APPLICATION FOR AUTHORIZATION TO INJECT

II. OPERATOR: Mewbourne Oil Company

Re: Form C-108 Application
QPBSU No. 13-2

Re: Completion Procedure - Revision 1
QPBSSU 13-2
Lea County, NM

OPBSSU 13-2**Proposed Procedure**

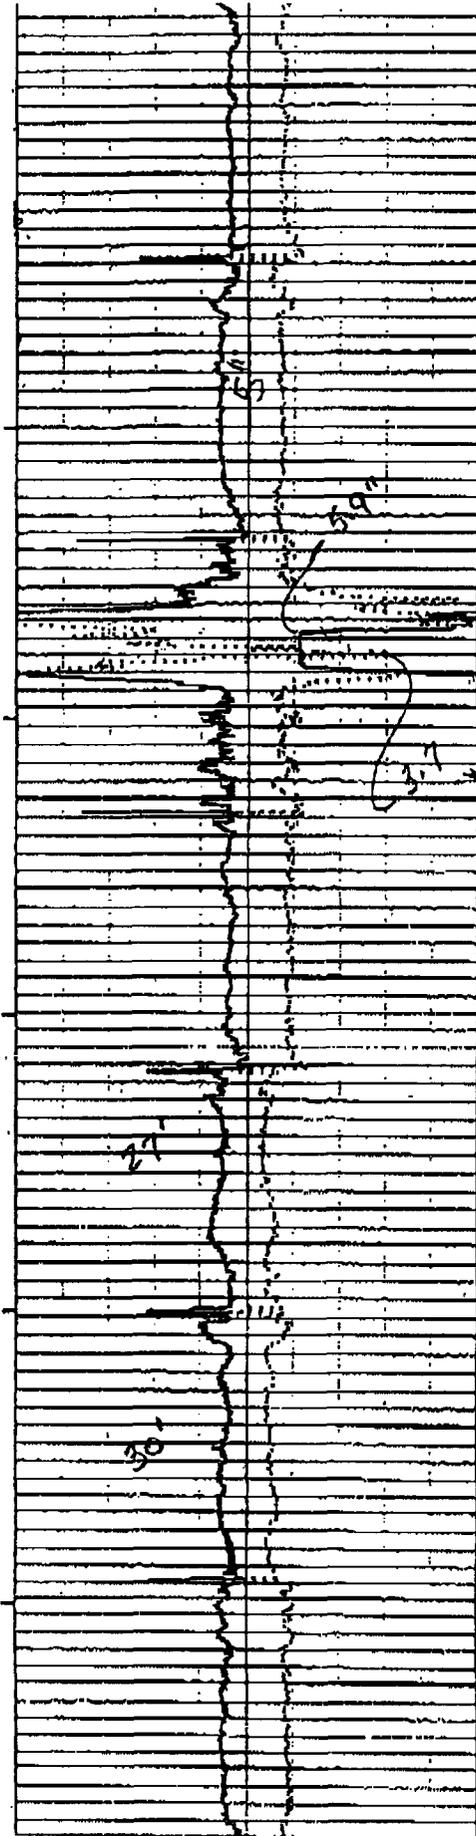
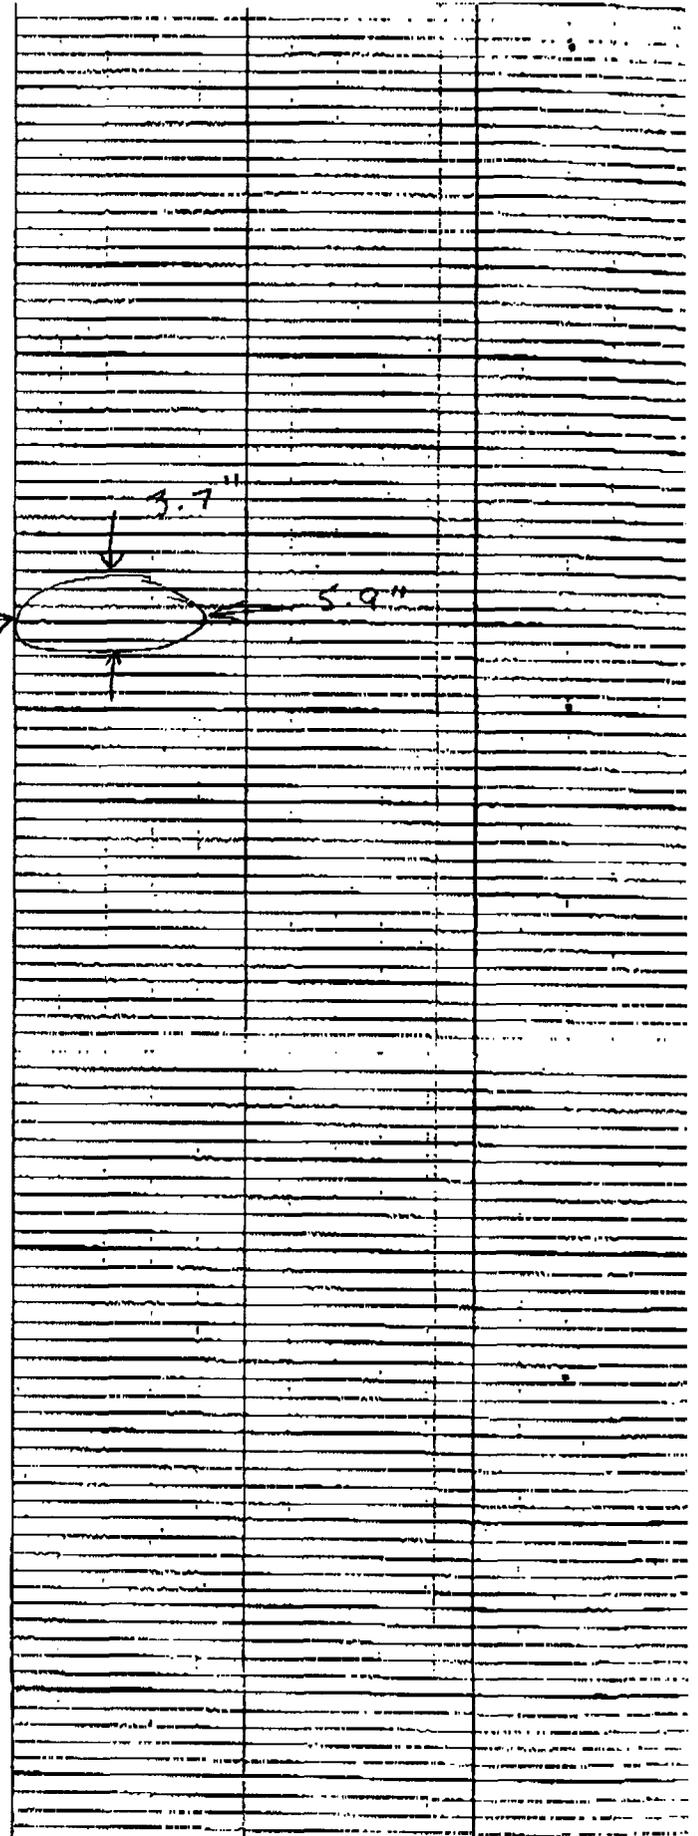
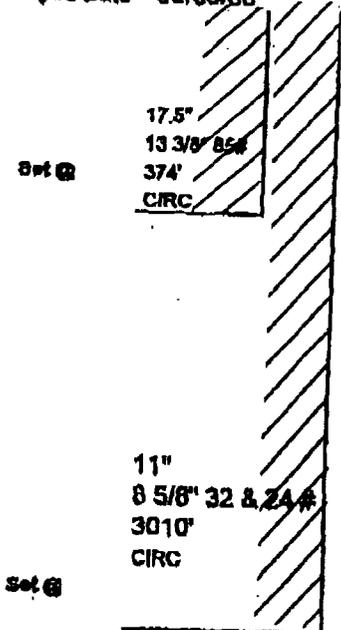
By Administrative Order No. WFX-776 dated August 24, 2001, you approved the conversion of the Querecho Plains Bone Spring Sand Unit (QBSSU) 13-2 from a producer to an injector. As preparatory work was being performed to insure the integrity of the well bore, it was determined an oval-shaped casing collapse had occurred between 2020'-2028' (see attached casing caliper log). After thorough consideration, it has been determined the better option to correct the problem will be to cement a string of 2⁷/₈" od lined tubing inside of the 5¹/₂" casing, thus forming a tubing-less completion as per OCD Part I, Section 702. This procedure, in fact, forms a cement packer over the entire length of the injection tubing. The attached schemat shows the tubing cemented in place. A proposed procedure is attached.

5 1/2" Casing Collapsed in oval shape 2020'-2038'.
(See Casing caliper log)

2 7/8" fiberglass-lined Tubing (Dualine)

Cement circulated in 2 7/8" x 5 1/2" annulus from bottom of tubing to surface.

1. Spot 20/40 frac sand approximately 50' above top perforations.
2. Run 2 $\frac{7}{8}$ " od Duoline tubing with fiberglass lining (2 $\frac{1}{4}$ " id). Centralize with aluminum centralizers.
3. Set bottom of tubing within 100' of top perforations (8459').
4. Conventionally cement tubing in place as if making a tubing-less completion as per procedure OCD Part I, Section 702. Note: The attached schemat shows the original placement of cement. The cross-hatched area is the placement of cement with this procedure. The 2 $\frac{7}{8}$ " tubing x 5 $\frac{1}{2}$ " casing annulus will be cemented from the bottom of the 2 $\frac{7}{8}$ " tubing to the surface.
5. Wash sand from bottom of hole with coil tubing.
6. Test and inject through 2 $\frac{7}{8}$ " fiberglass-lined tubing.

Querecho Plains Bone Spring Sand Unit
Well 13-2 - Revision 1

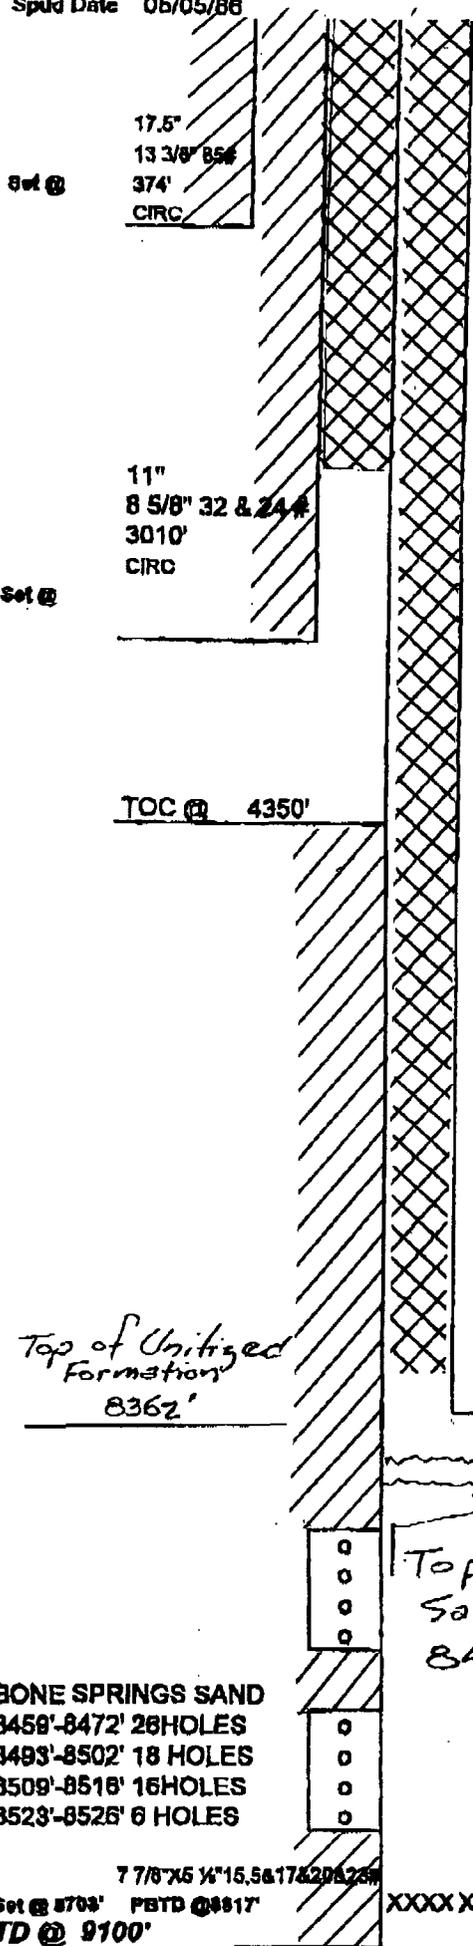
The collapse of the 5½" casing at 2020', plus the confirmed leak in the same area, emphasizes the need to leave the 5½" casing as it is and not try to remove or repair the casing due to its poor mechanical condition. The cementing of tubing to make a tubingless completion is by far the best alternative.

The attached recommended procedure plus the wellbore schematic shows the placement of the tubing and cement. The placement of cement has been discussed in detail. First, there is 13¾" casing set at 374'. Should there be any fresh water in the area, it typically is no deeper than 200'. The fresh water sand is protected. Next 8¾" casing is set to 3010' with cement circulated to the surface. The 5½" casing has good cement to 4350'. The proposed procedure provides cementing the 2⅞" x 5½" annulus to within 100' of the top of the Unitized Formation to the surface. The 5½" x 8¾" annulus will be cemented from area of leakage, 2020'-2038' to surface. The surface sands will be protected by four strings of steel pipe (1.538") and 7.5" of cement. This is considered adequate to protect any surface areas. Measurement of displacement fluid is extremely critical to assure leaving no cement in the tubing or below the tubing, and still maintain cement no higher than 100' above the Unitized Formation.

The tubing will be internally lined with Duoline fiberglass. The top joint and bottom 10 joints of tubing will be externally coated with epoxy. To insure integrity of the system, a cement bond log and an injection profile log will be run.

Circulate cement in 5 1/2" x 8 5/8" annulus from 2038' to surface

5 1/2" CSG collapsed at 2020'-2038' Hole verified in same area.

2 7/8" Ev E 8rd, J-55, 6.5#/ft internally coated w/ Duoline fiberglass. Top joint & 10 bottom jts externally coated w/ epoxy.

Circulate cement in 2 7/8" x 5 1/2" annulus from approximately 8262' to surface.

Bottom of Cement Approx 8262'
Bottom of Tubing - 8350'

1. Place 10' of 100 mesh sand to cap sand plug.
2. Rig up WO rig. Install BOP.
3. Pick up 2⅞" od EUE 8rd J-55 6.5#/ft. tubing lined with Duoline fiberglass, 2¼" id w/WL entry guide. Bottom 10 jts. and top joint to be externally coated with epoxy.

4. TIH w/tubing open-ended. Centralize from bottom up jts. 1, 2, 3, 5, 8, 11, 14, 17, 20, 23, 26, 29, 32.
5. Set bottom of tubing @ 8350'. Top of Unitized Formation as defined in Unit Agreement Section 2.11 (Equivalent depth 8362')

7. RD BOP's
8. Hang tubing with top and bottom-threaded type G adapter flange.
9. Design cement job based on test from item 6 above.
10. Circulate cement in place to fill 2⅞" x 5½" annulus from approximately 8262' to surface and 5½" x 8⅝" annulus from 2042' to surface. Follow cement w/10 bbls. cross link gel for wiper. Cement volume approximately 193 bbls. Pump 10% excess cement.

11. Flush cement to bottom with total 42.4 bbls. (10 bbls. gel + 32.4 bbl. FW). (Tubing set approximately 8350' w/13' zero above THF)
12. Hold pressure on tubing to balance cement plug. Bottom of cement in 2⅞" x 5½" annulus calculated to be at approximately 8262', 100' above top of Unitized Formation.
